ADDENDUM

PROJECT	Black Hawk County Courthouse Renovations	PROJECT #	23109
OWNER	Black Hawk County	DATE	January 19, 2024
LETTING DATE	January 29, 2024	ADDENDUM #	1

4 MEPT – see attachment with MODUS titleblock noted "Addendum #1".

SHEET E2.01 | BASEMENT LIGHTING PLAN

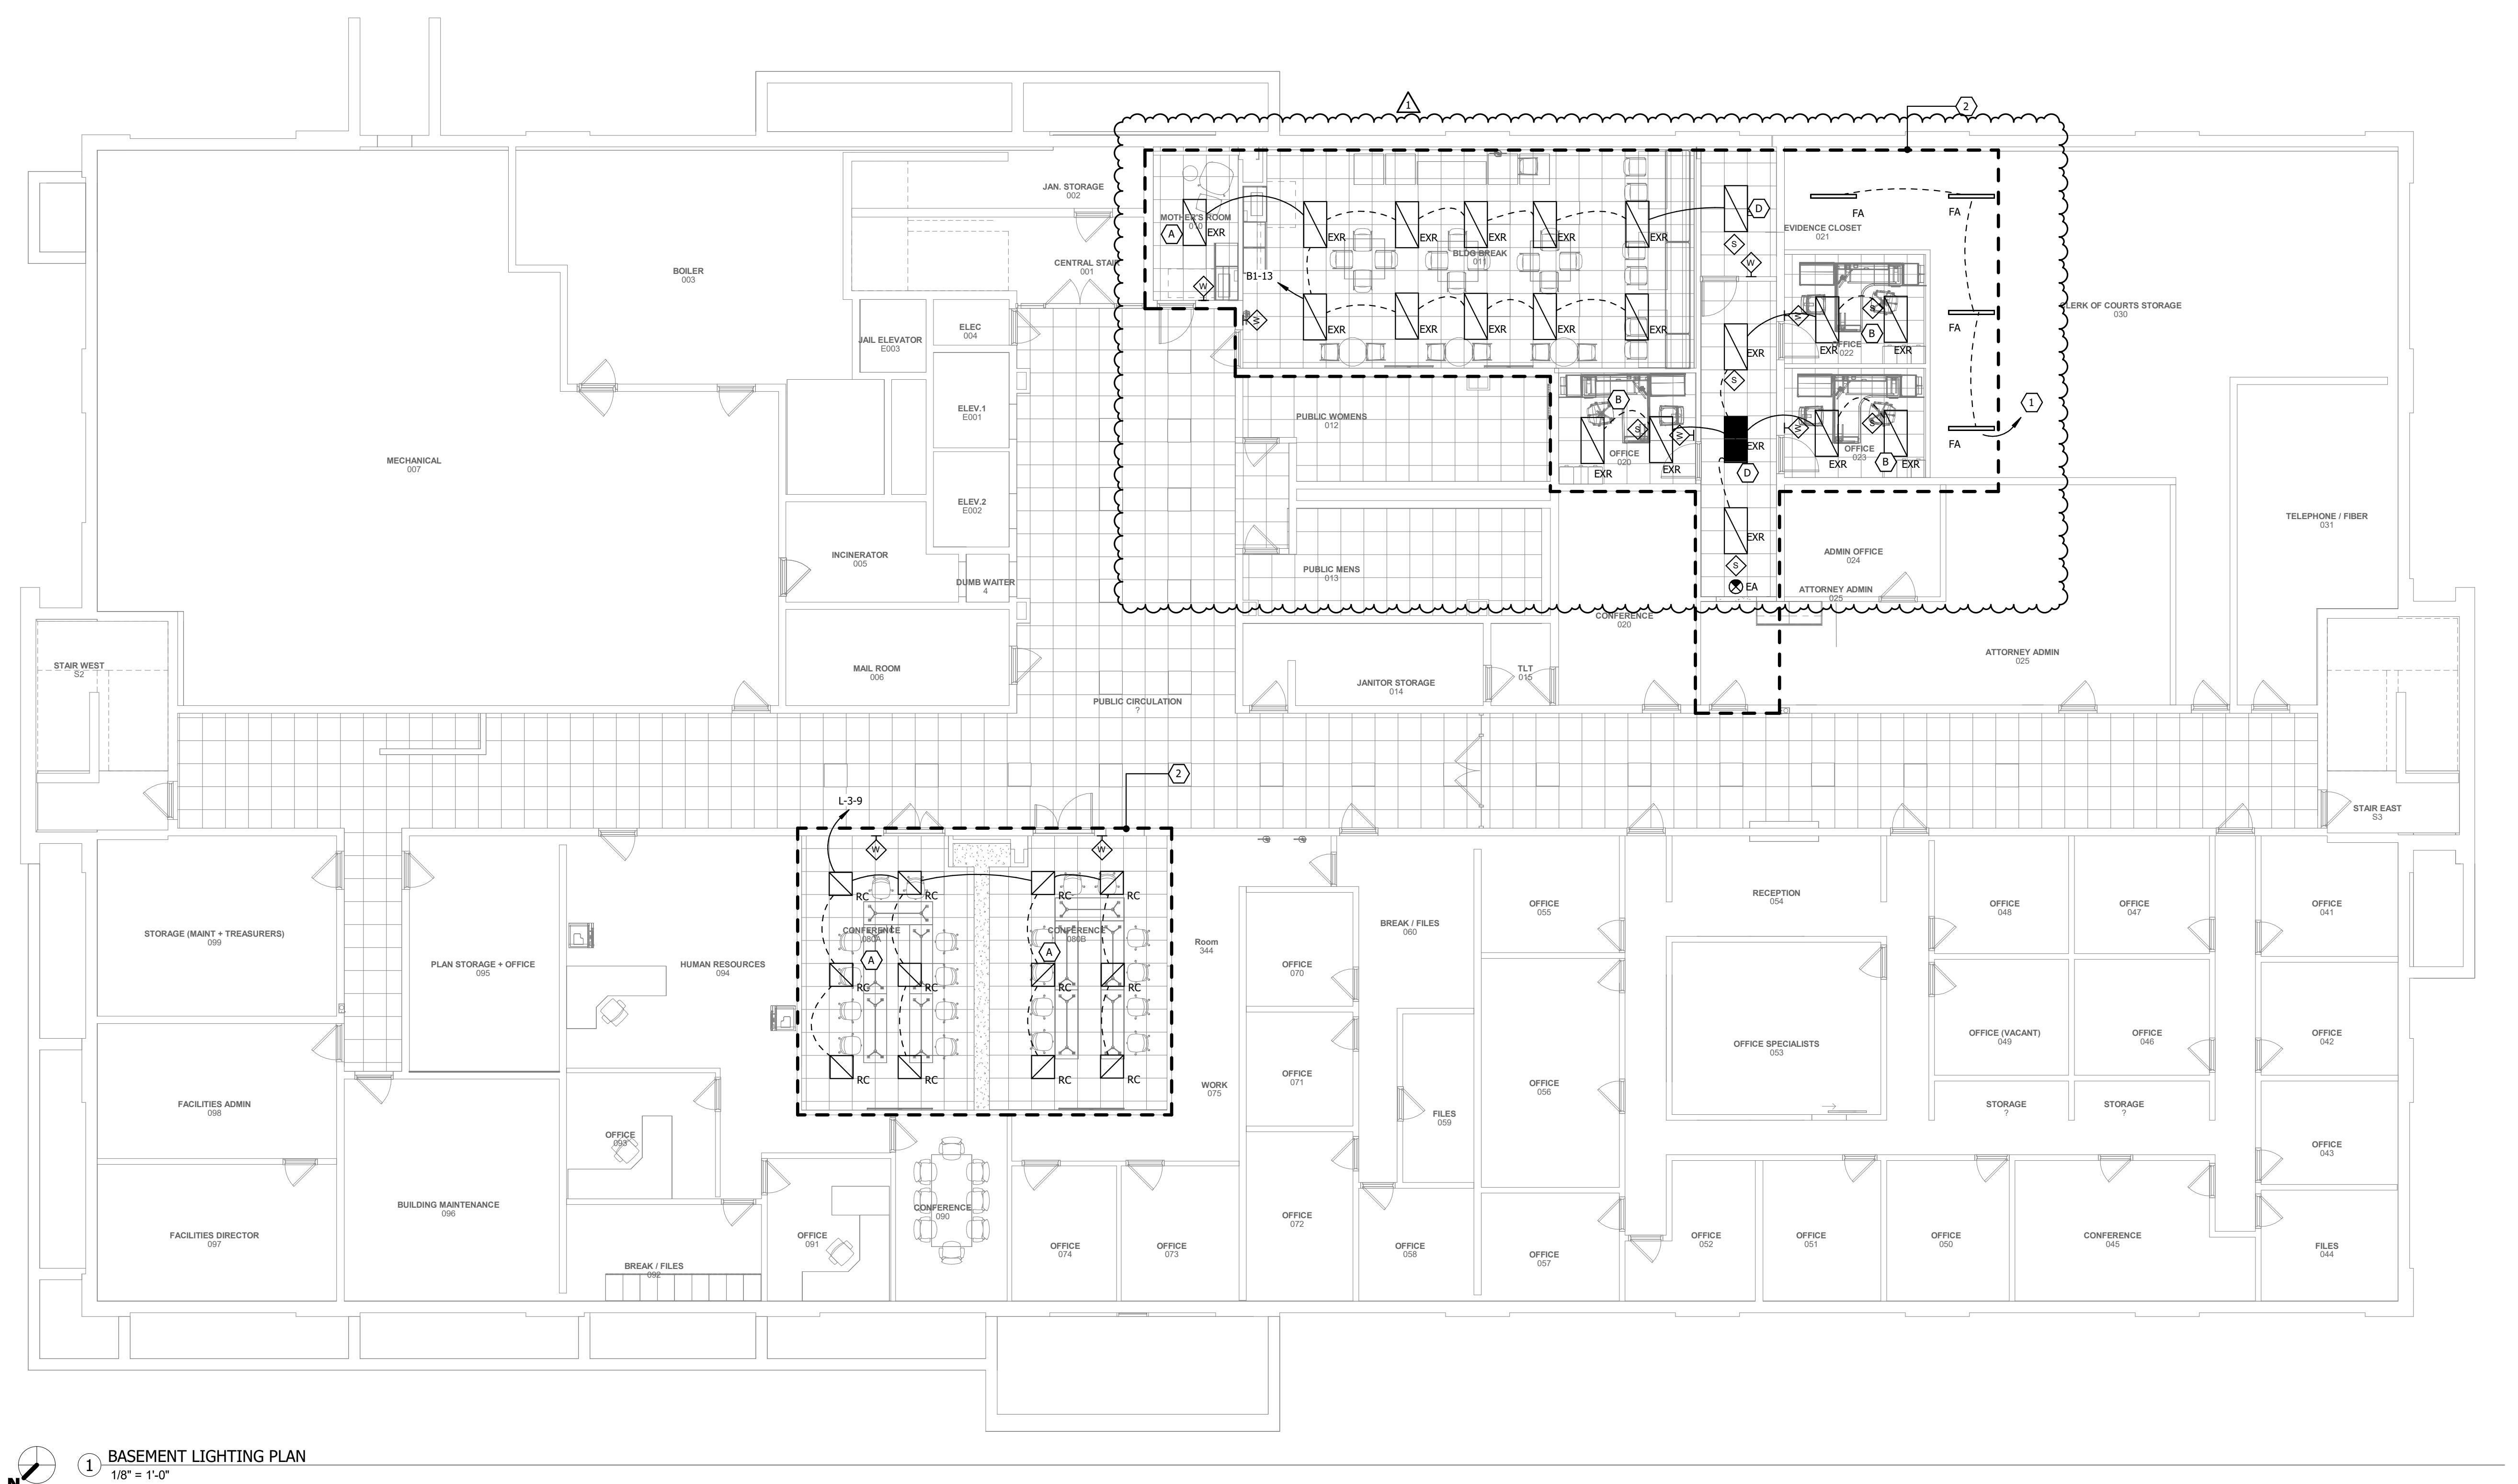
1. **REVISE.** Revise lighting layout and quantities to account for existing to be reused fixtures.

SHEET E2.02 | FIRST FLOOR LIGHTING PLAN

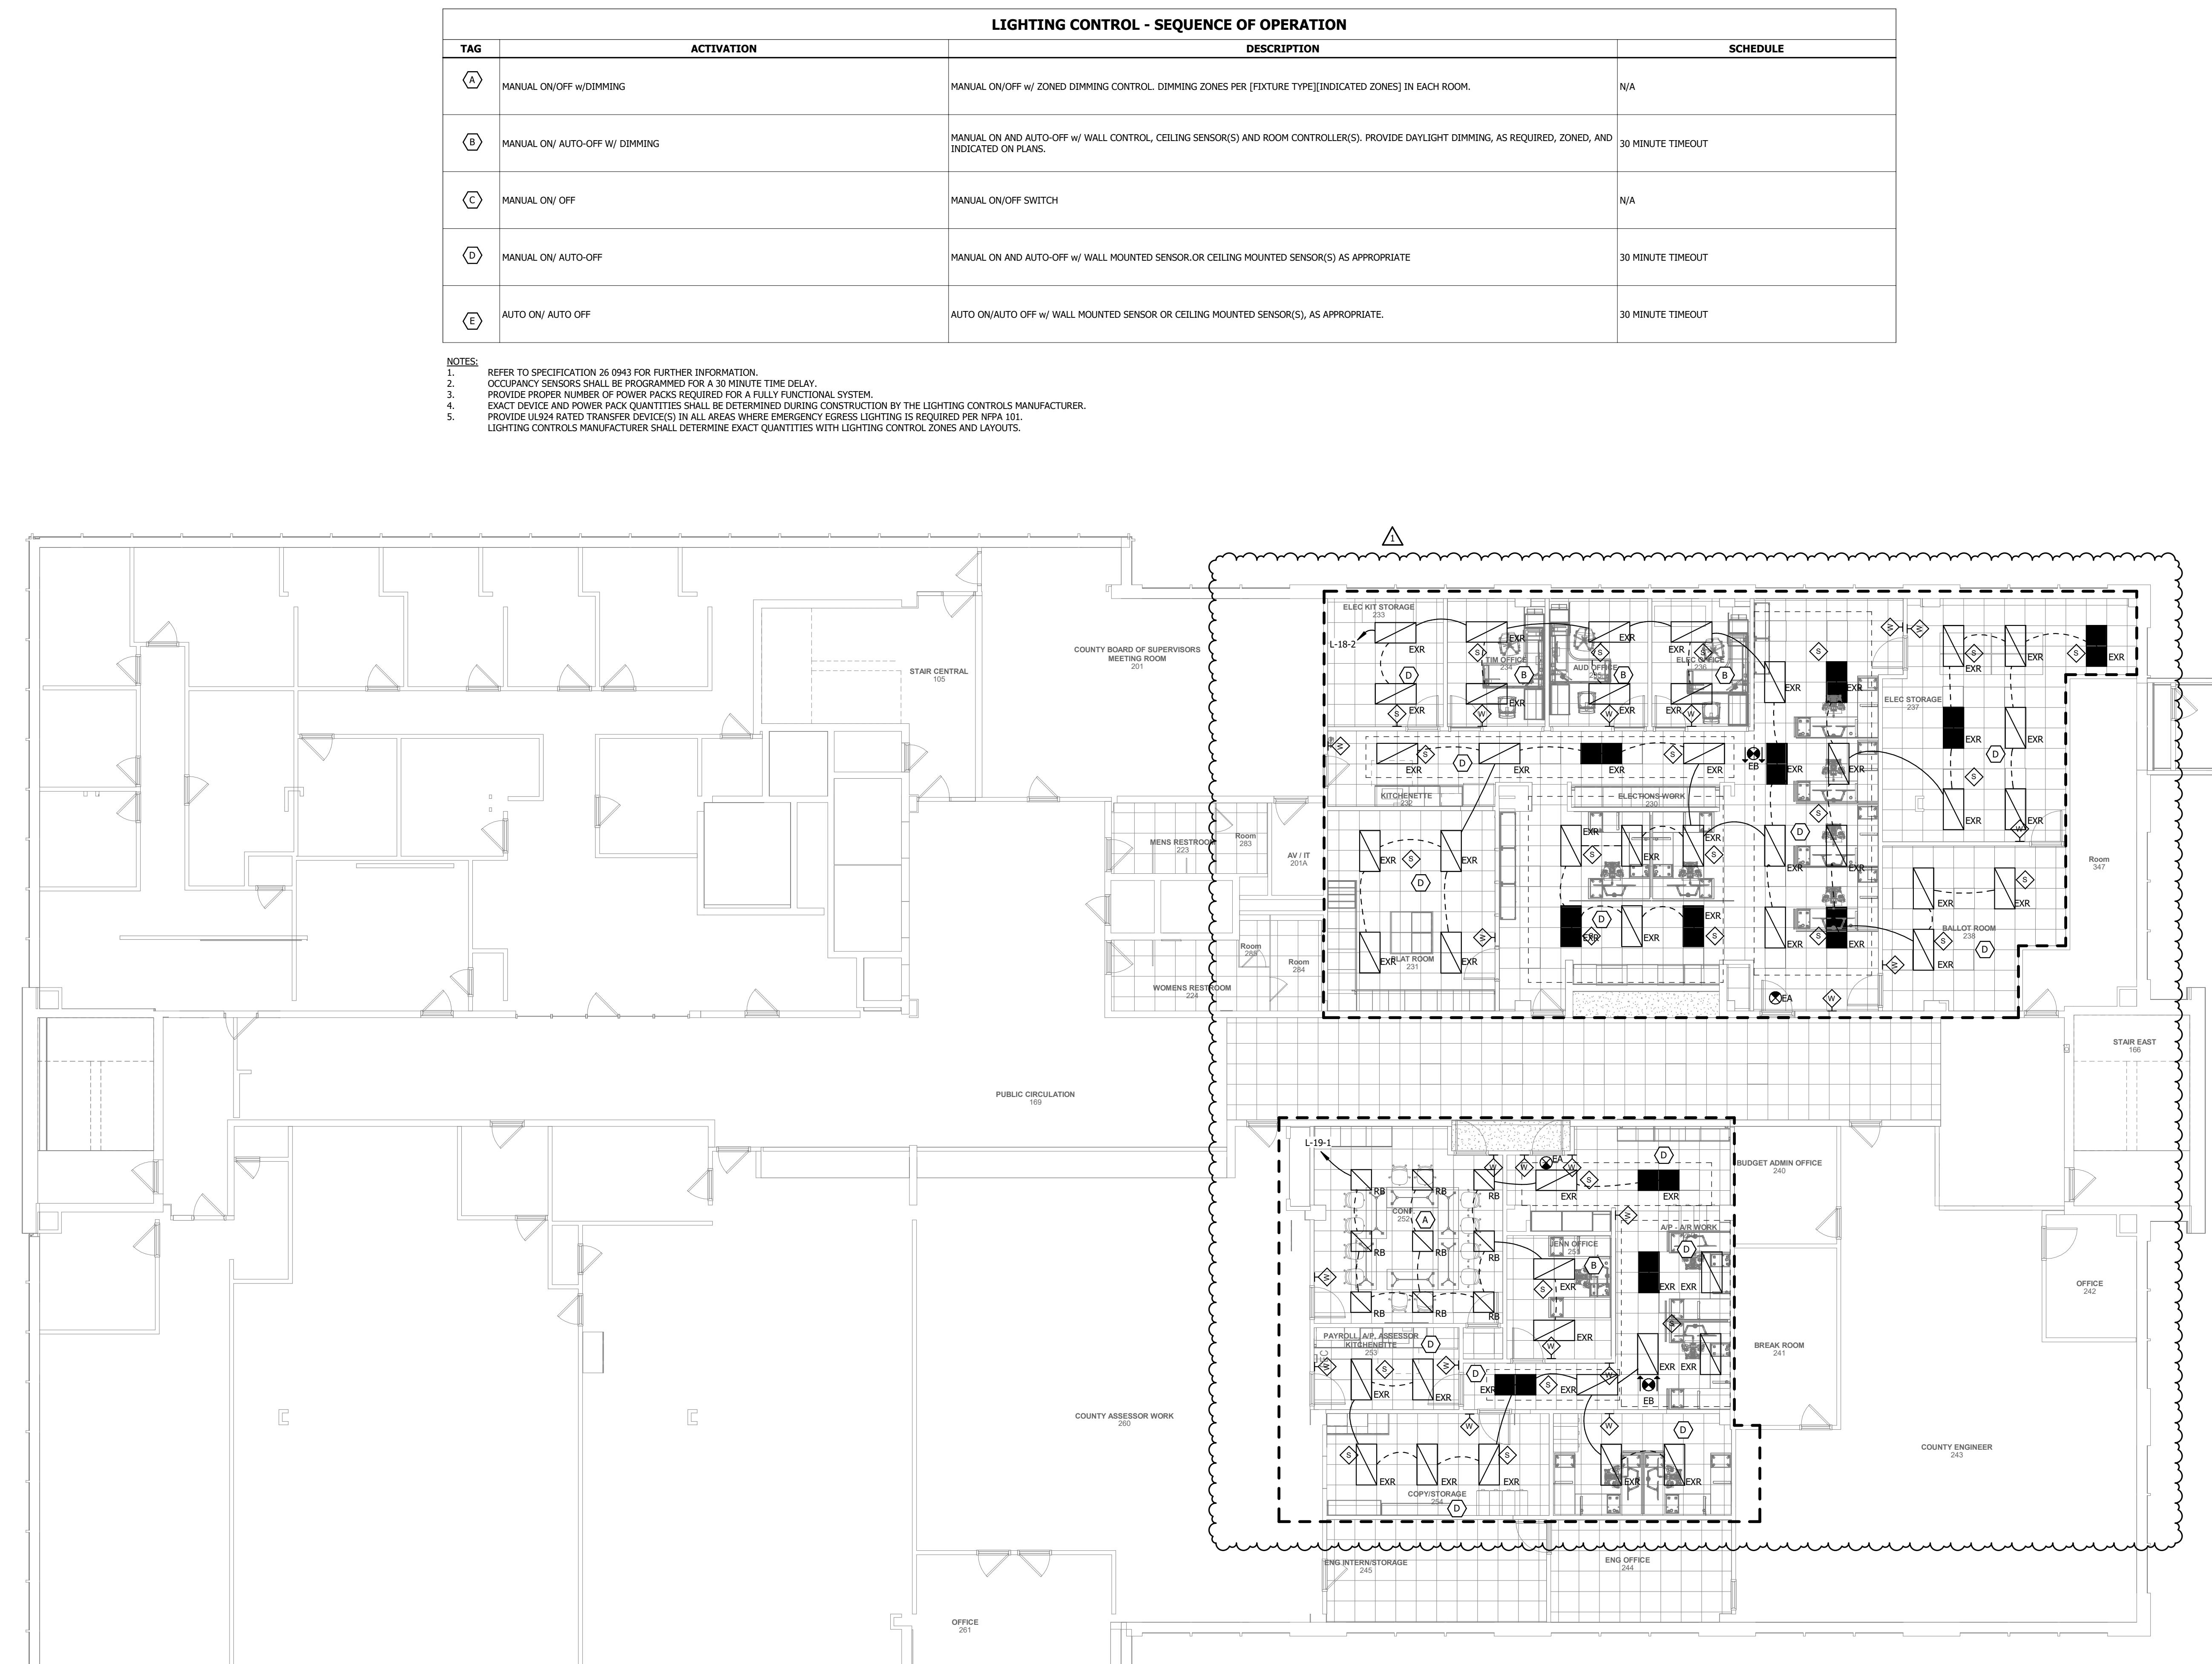
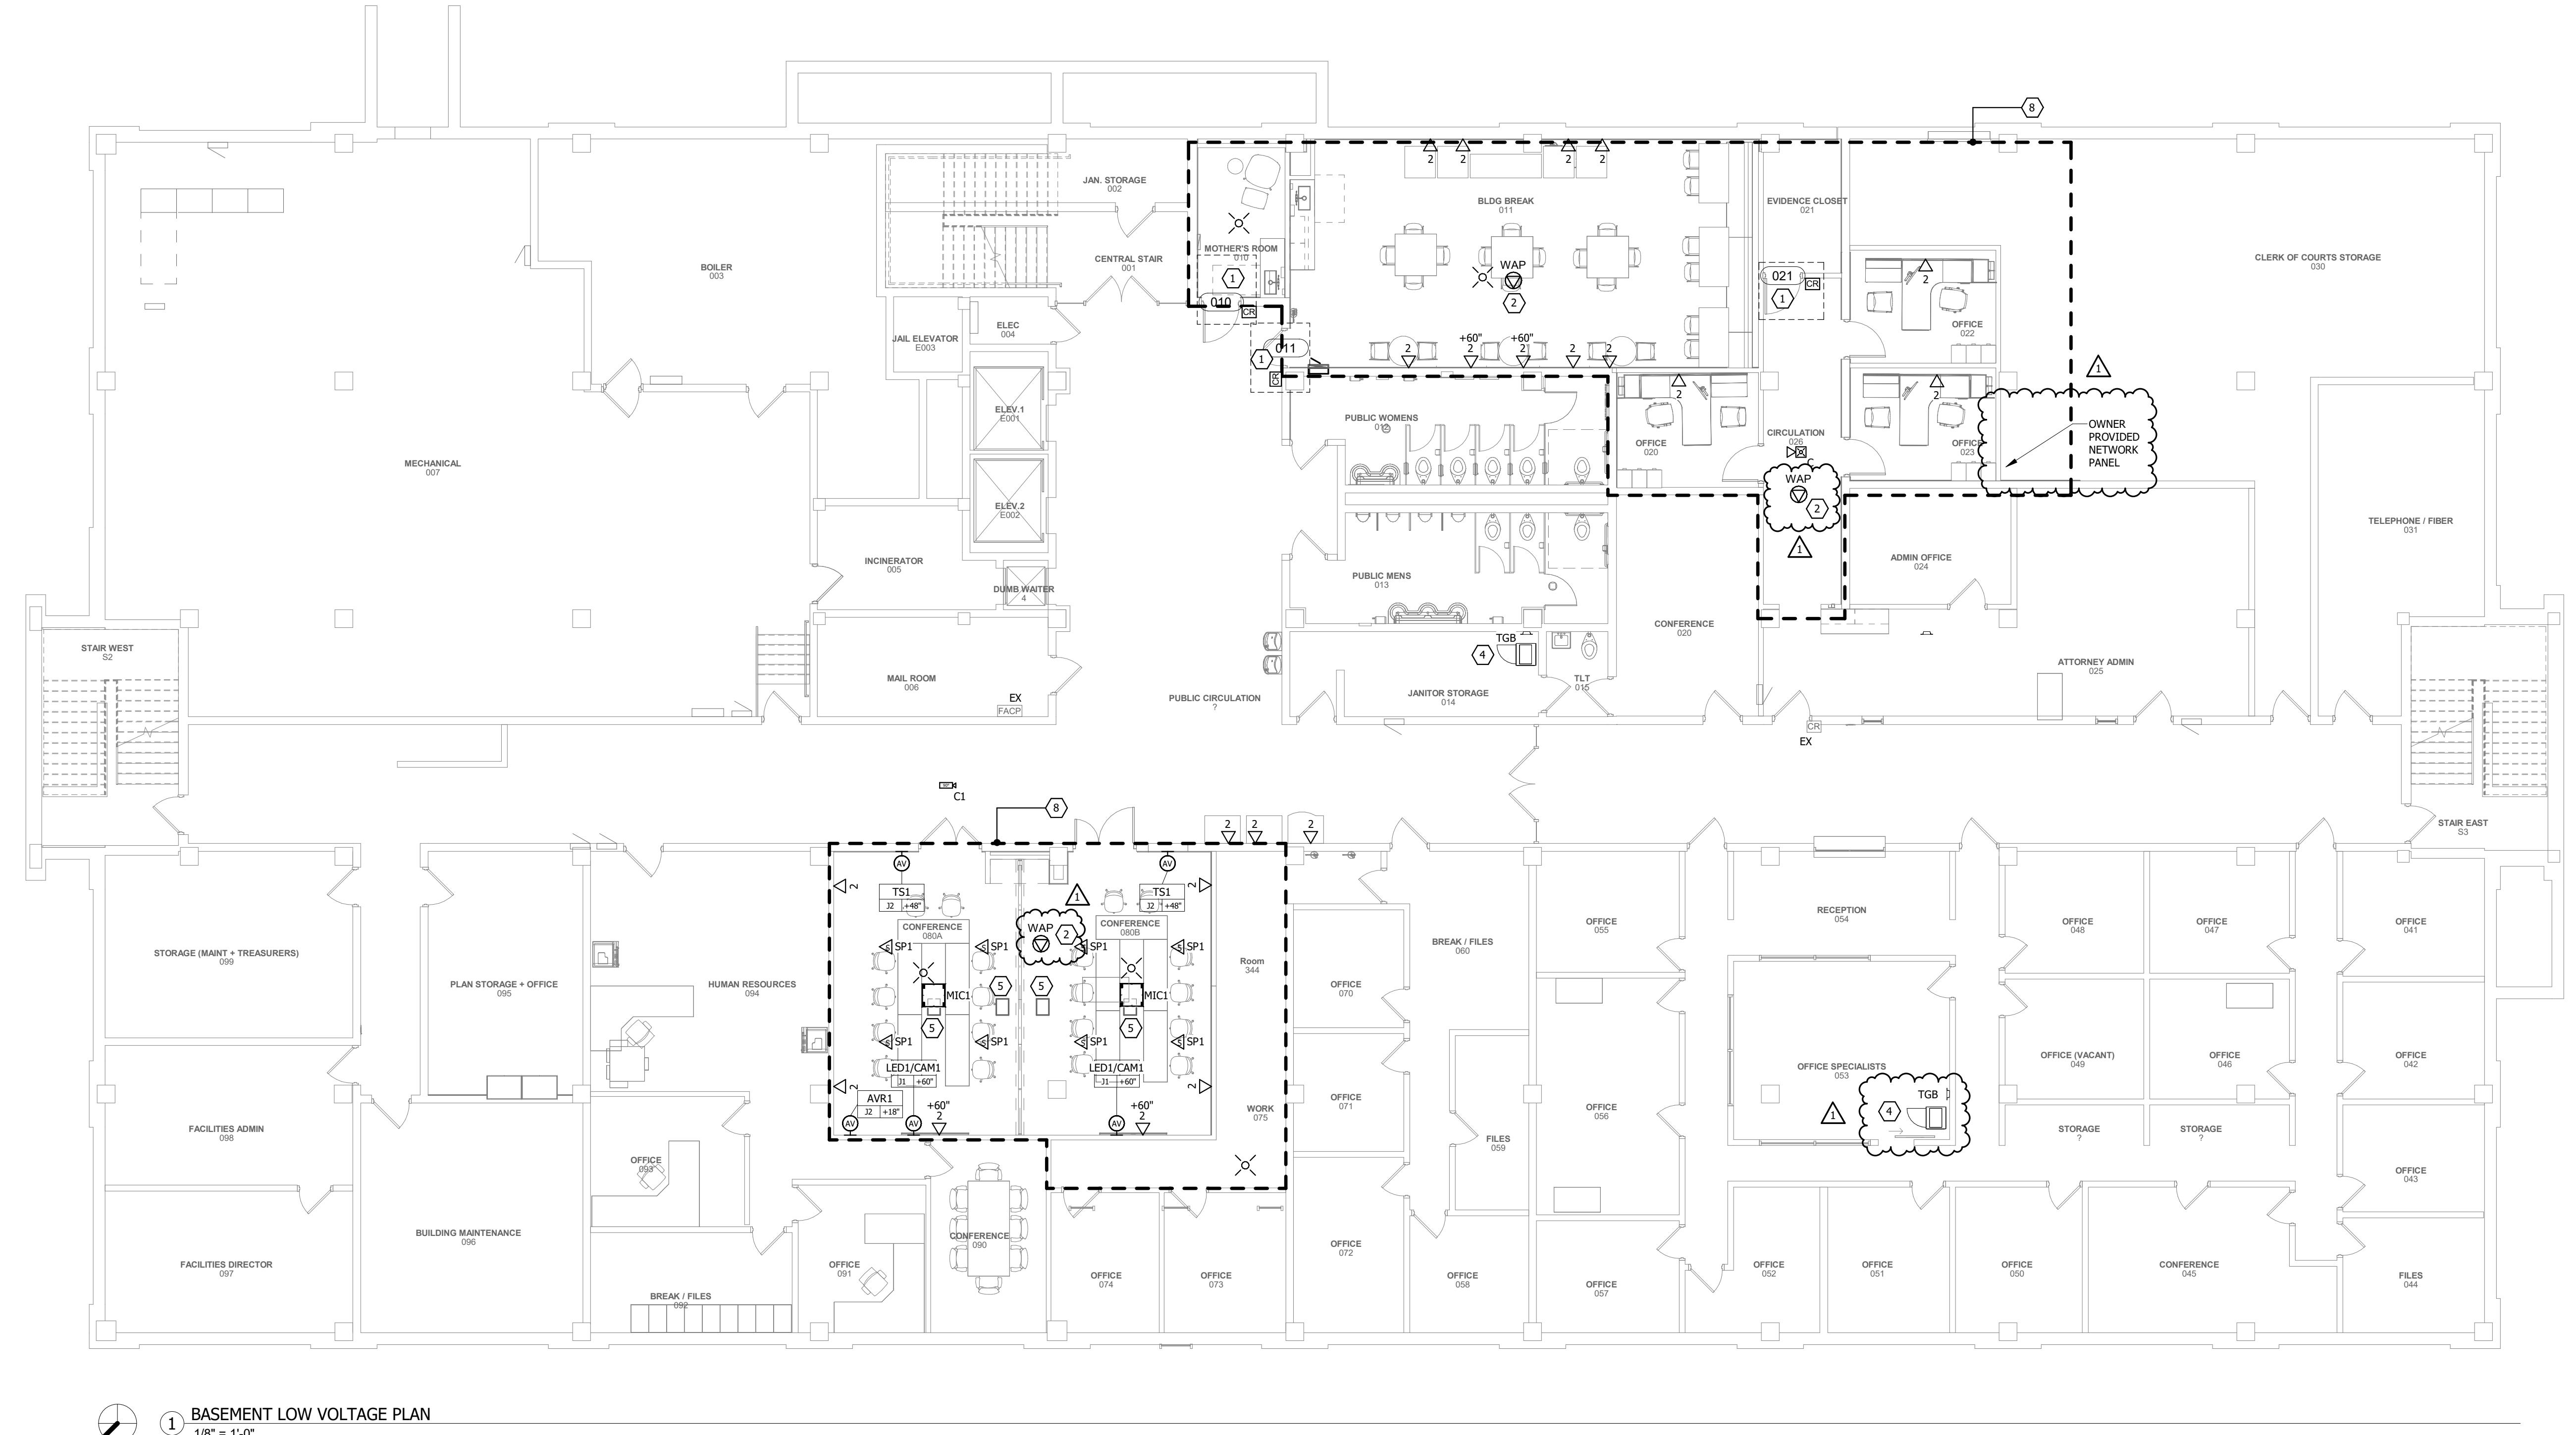
1. **REVISE.** Revise lighting layout and quantities to account for existing to be reused fixtures.

SHEET E2.03 | SECOND FLOOR LIGHTING PLAN

1. **REVISE.** Revise lighting layout and quantities to account for existing to be reused fixtures.
